**ADDENDUM NUMBER ONE (1)
TO THE PLANS AND SPECIFICATIONS FOR:**

July 24, 2026

**Harmony Public Schools
Harmony Science Academy
City Place Phase 2
New High School / Middle School
22000 Springwood Village Pkwy.
Spring, Texas 77077
Project No. 24.23**

**GIGNAC & ASSOCIATES
416 STARR STREET
CORPUS CHRISTI, TEXAS 78401
(361) 884-2661**

Item P- 2 Sheet G-003 Code Review

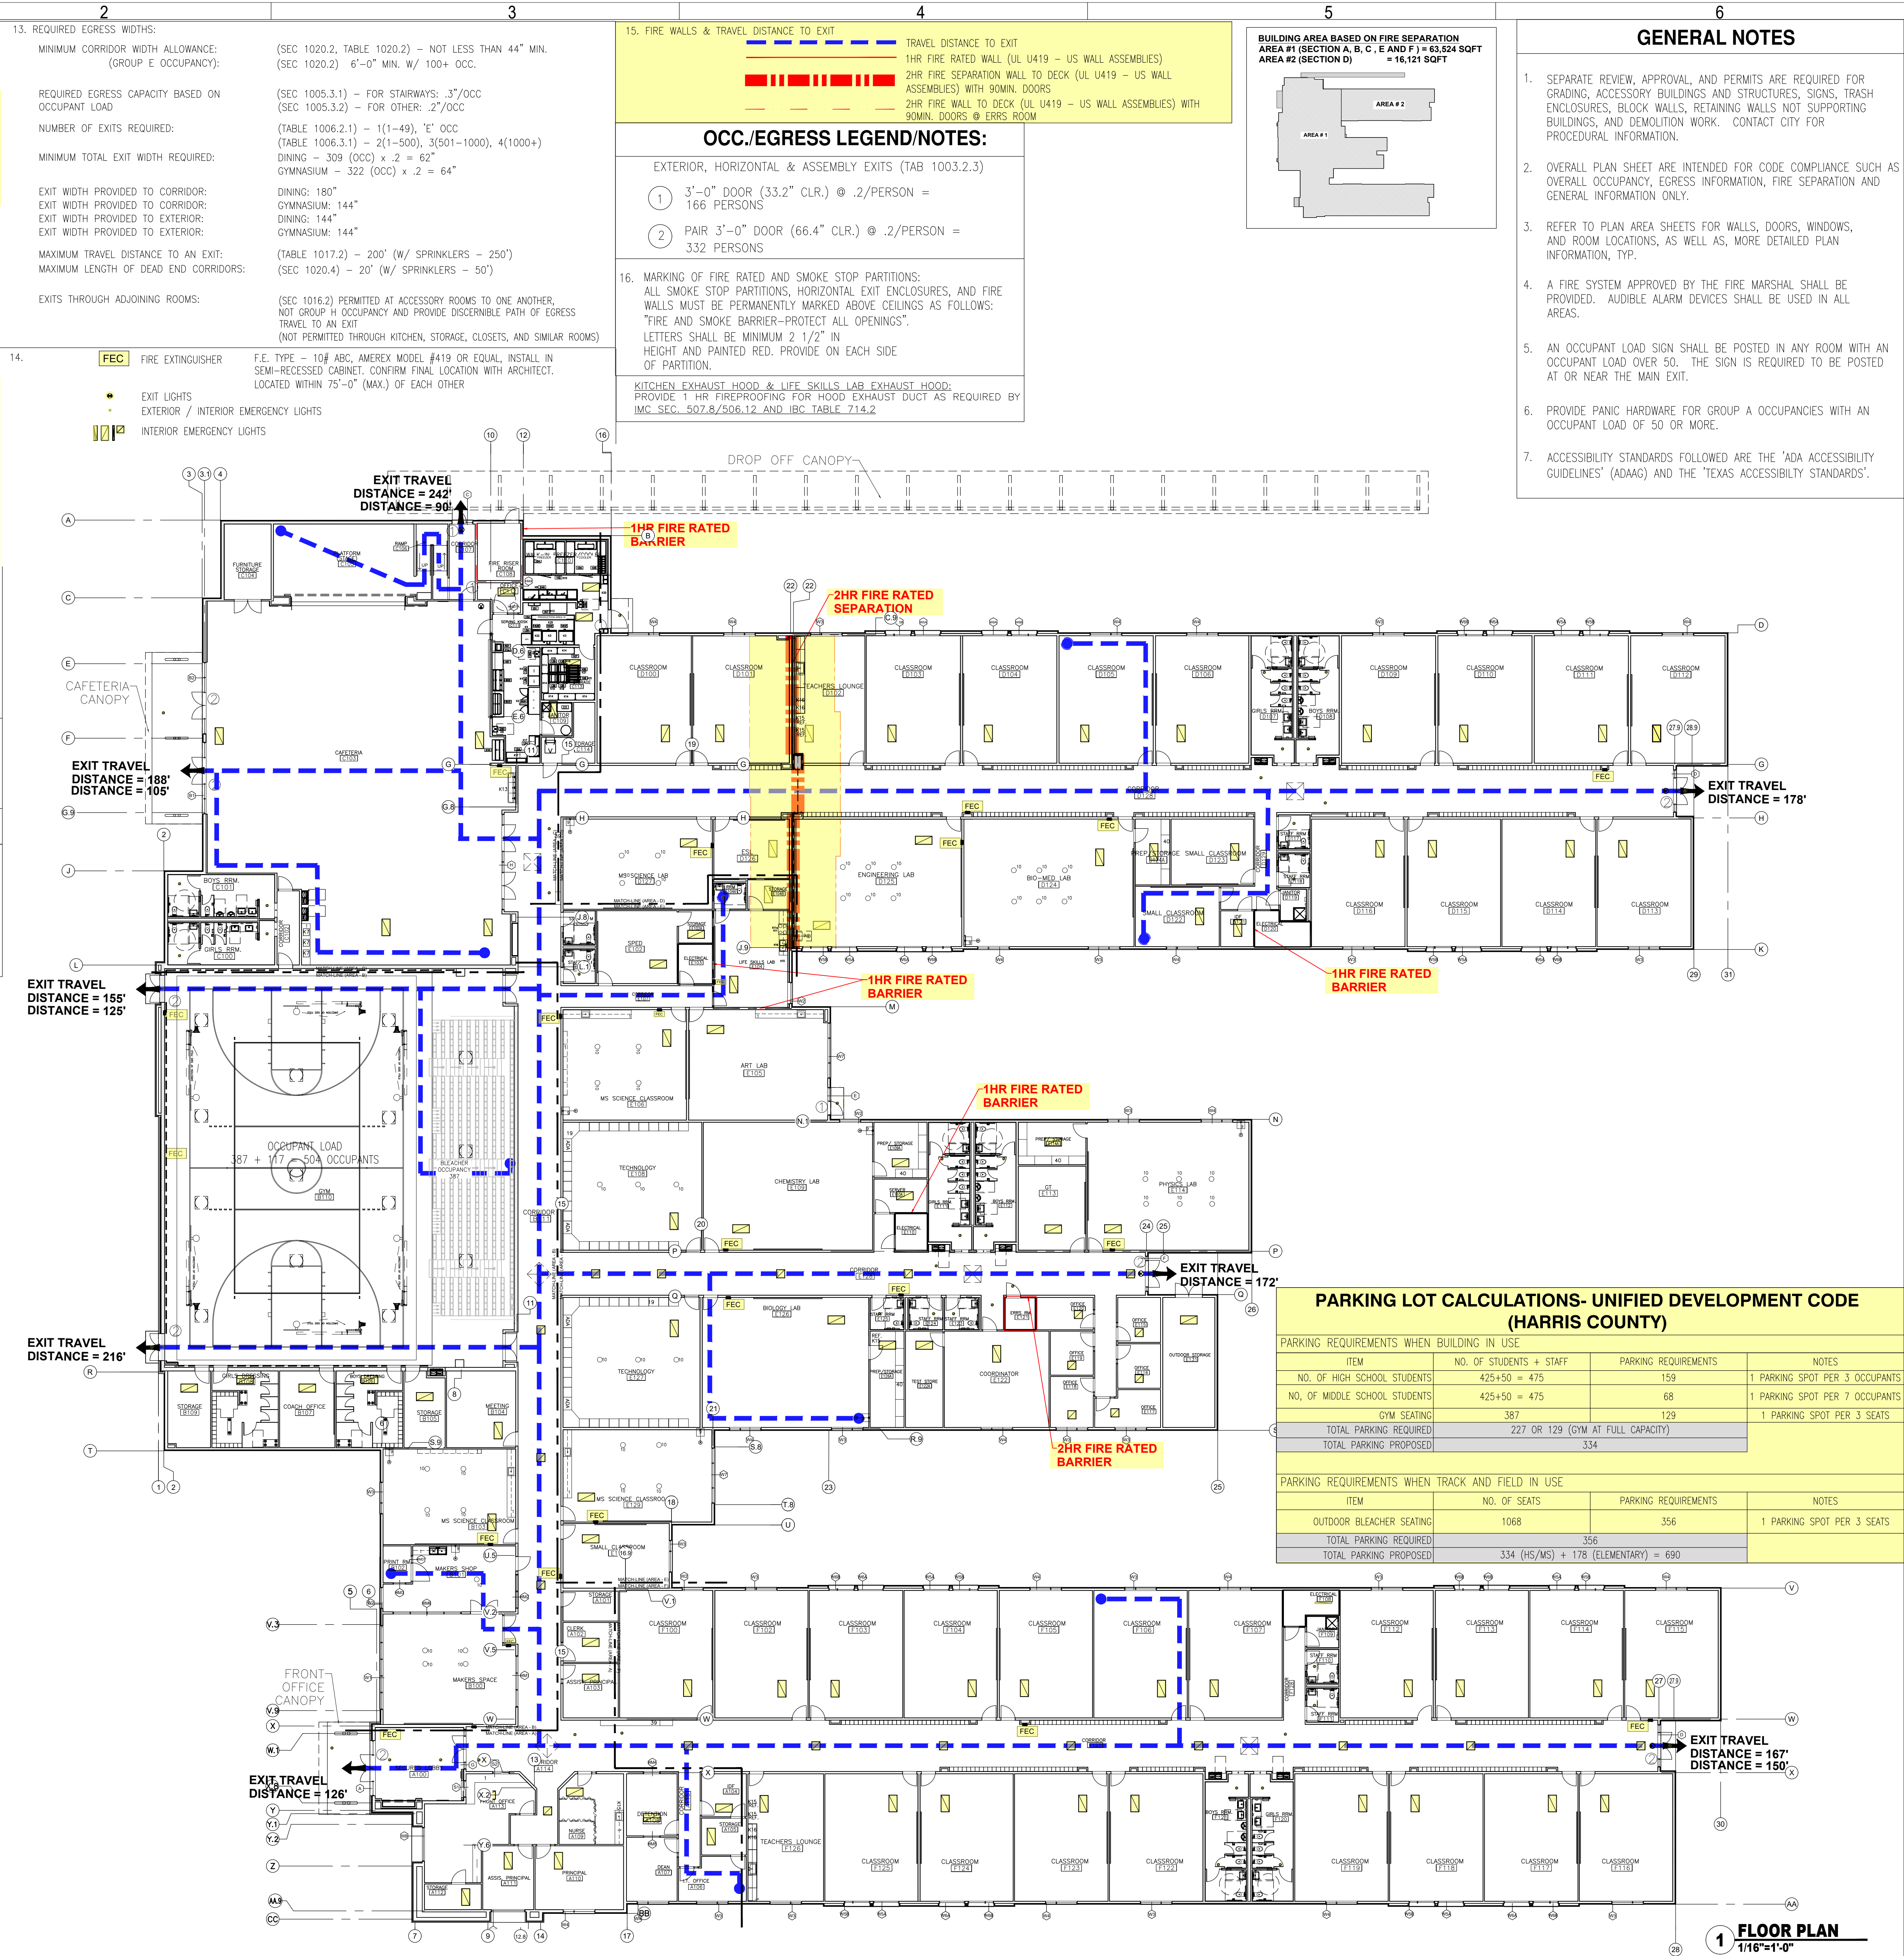
Question 2: Spec 078116 calls out Type IB Construction ratings; however, Code Sheet G-003 calls out Type IIB Construction ratings (0-HOUR). I am assuming the Type IIB on the Code sheet is correct and NO FIREPROOFING will be required. This is typical for 99% of Harmony schools historically. Please confirm the Construction Type, IB or IIB.

Answer 2: Construction Type II-B (Non-Rated)

1. Delete this sheet in its entirety and replace with sheet G-003, included within this addendum.
2. Location address updated.

Sheet Title:
SITE TRACK AND FIELD DETAILS

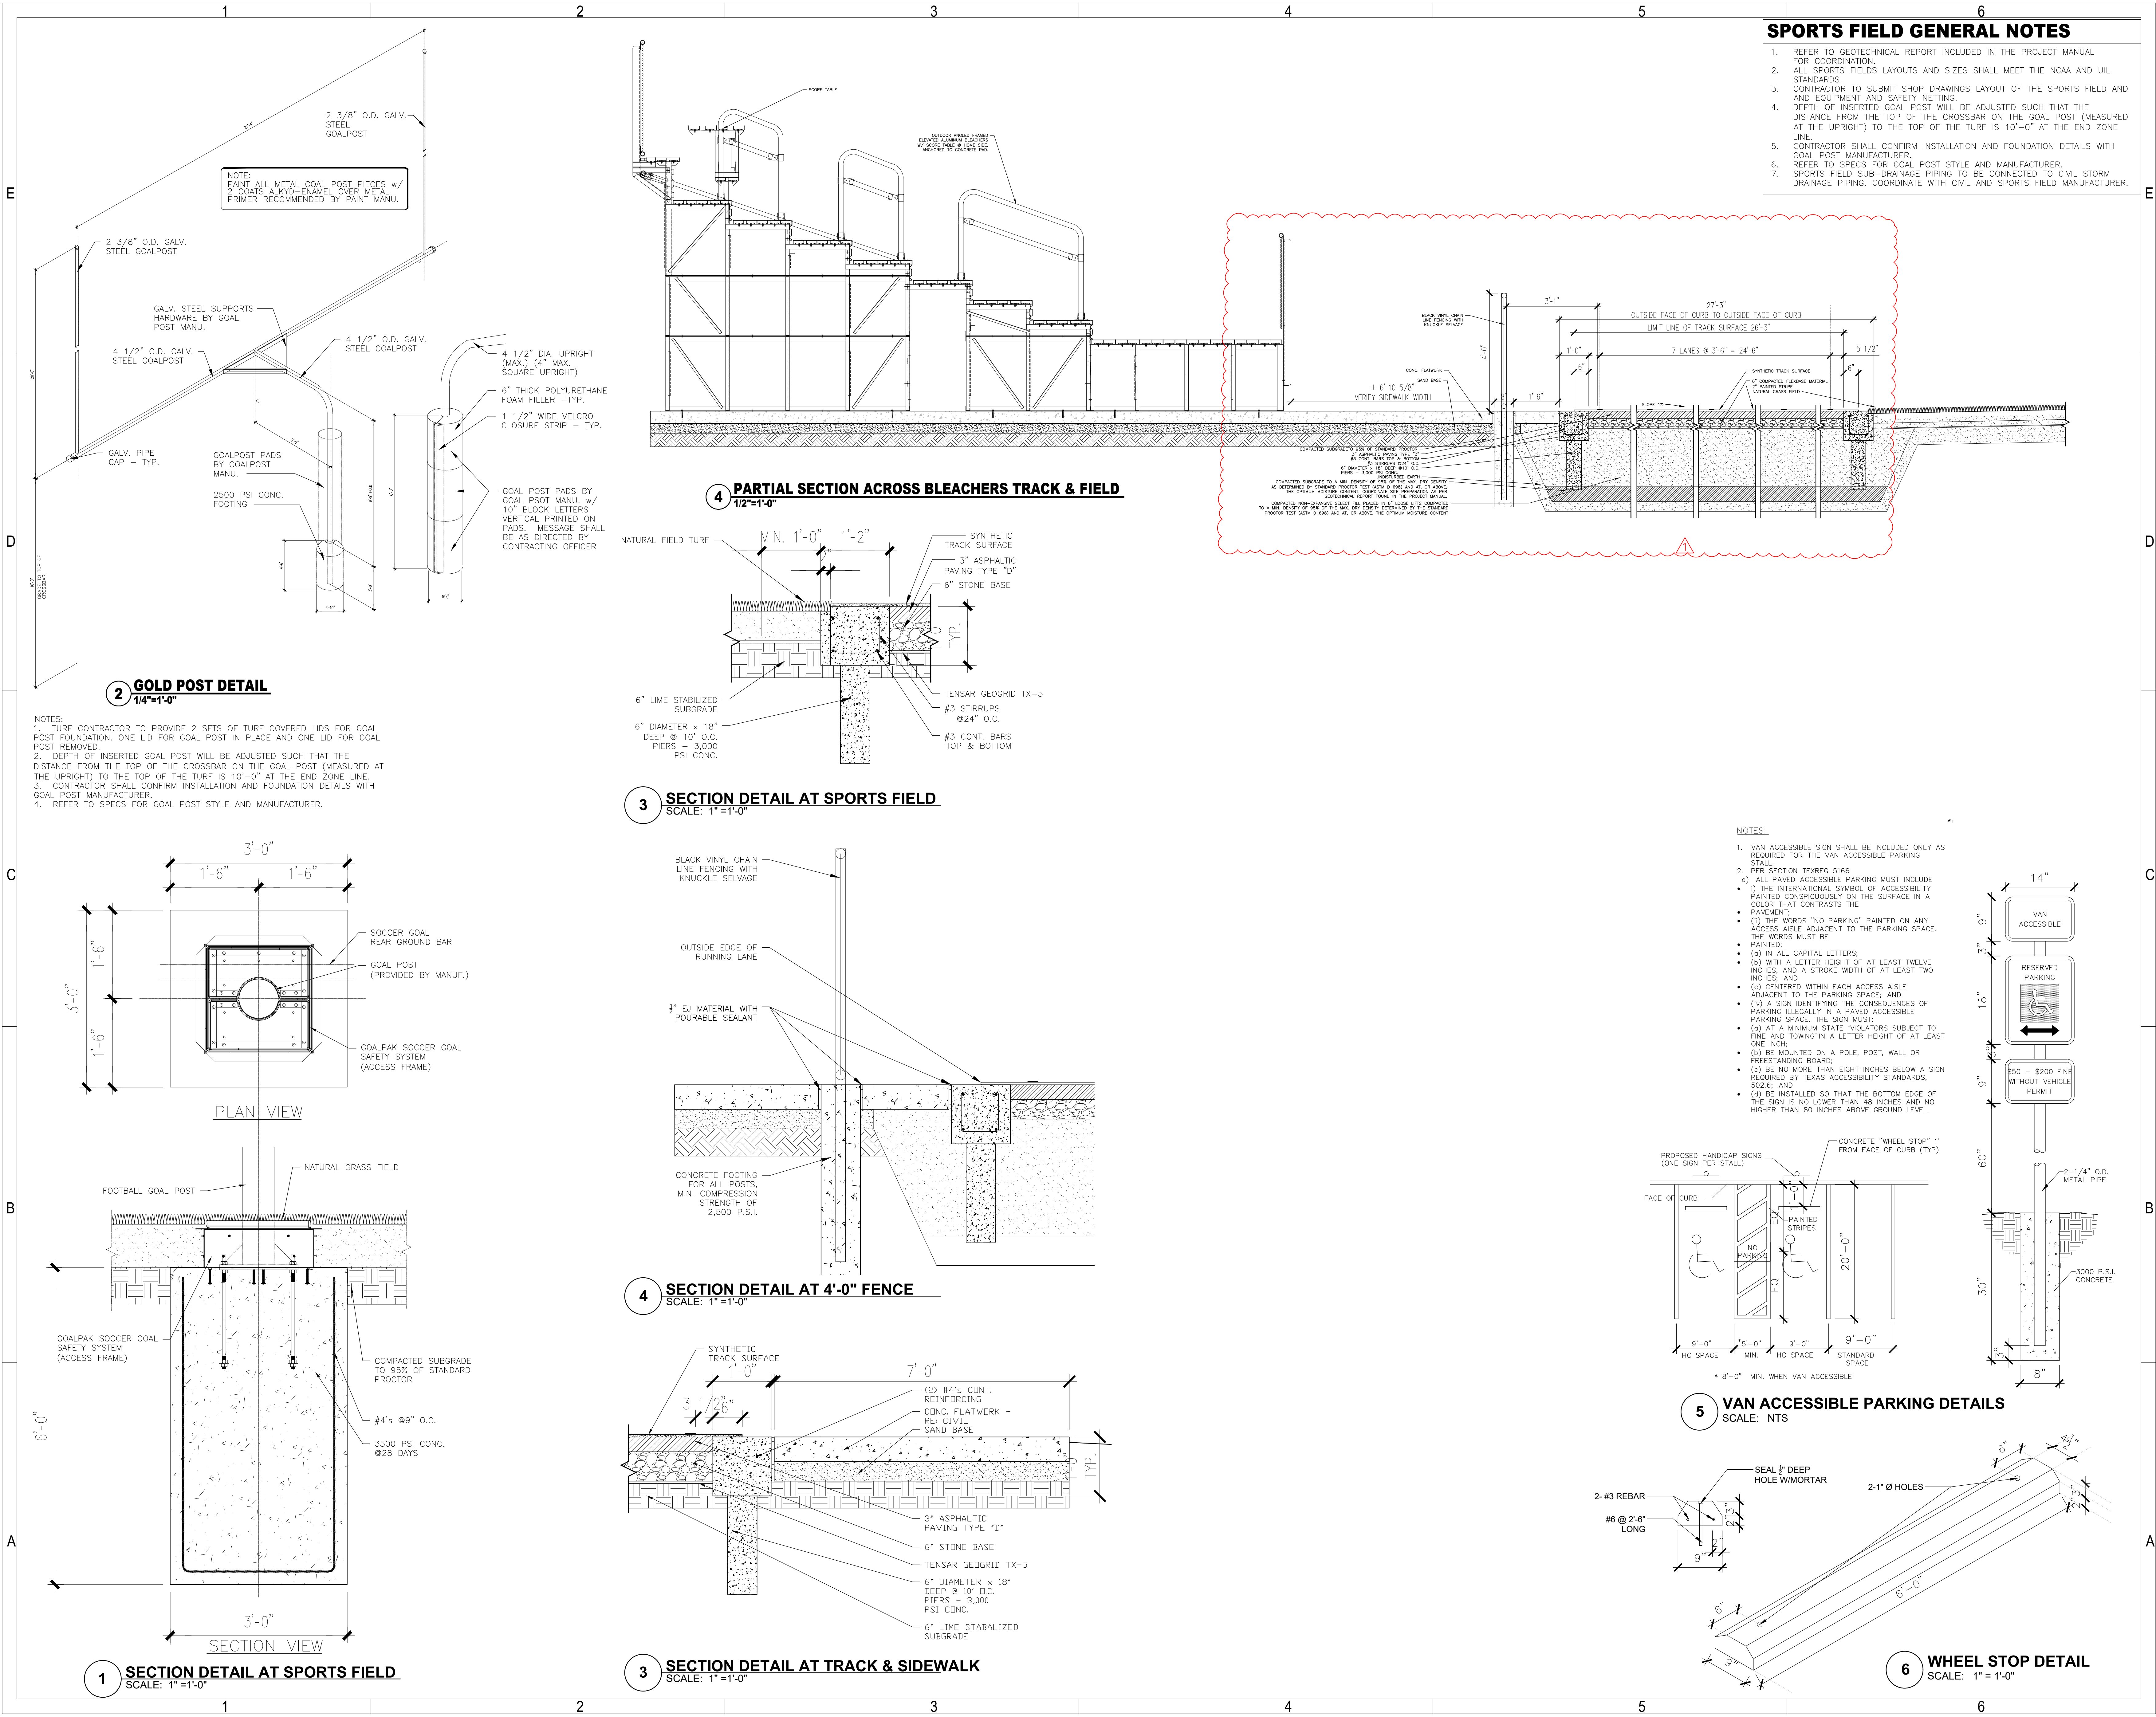
Item P- 3 Sheet AS-106 Site, Track and Field Details

1. Delete this sheet in its entirety and replace with sheet AS-106, included within this addendum.
2. Detail 4 – Partial section across bleachers track and field updated.
